## FIELD INSPECTION

| <b>Project Name:</b>                      | Mountain Valley Pipeline  | <b>Inspector:</b>              | Matthew Grant |
| <b>Inspection Date:</b>                   | Tuesday, February 5, 2019 | <b>Project Contact:</b>        | Brian Clauto  |

## FIELD INSPECTION PHOTO LOG

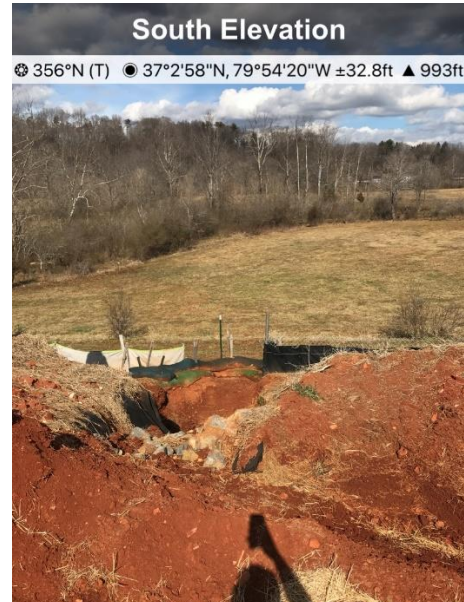
- Fig. 1 St#13955+05 P1 fence requires maintenance

- Fig. 2 St#13919+00 sump inlet requires maintenance

- Fig. 3 ATWS 698C P1 fence and CFS requires maintenance

- Fig. 4 St#13909+08 slope requires repair and stabilization

**Recommended Corrective Action:** Maintain all controls per the approved plan and specs.
